Product Change Notification – #3003451

Title: Material Change – Bolt

Product	Part Number	Model Number
16V 58F Ultracapacitor Module	135808	BMOD0058 E016 C02

Current Bolt	New Bolt
Product Image – Bolt

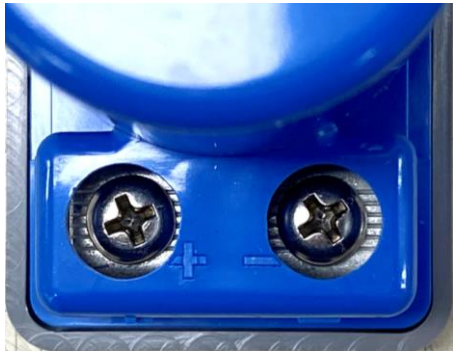
The current bolt that gets connected to power terminals will be replaced with a new bolt. The new bolt is an off-the-shelf part that can easily be purchased without supply risk. The new bolt has been verified via torque and assembly testing. Please refer to the images and test data below.

Current Bolt	New Bolt
Product Image – Module		
Material	Brass Plated with Nickel	SS304 (Type 304 Stainless Steel)
Torque Test [Spec: 4.0 Nm]	-	Tested with 45kgf•cm (≈ 4.4Nm) Result: PASS, 10 out of 10 pcs

Difficulty in procuring the current bolt – reduce the supply risk by switching to an off-the-shelf part that is compatible with the product.
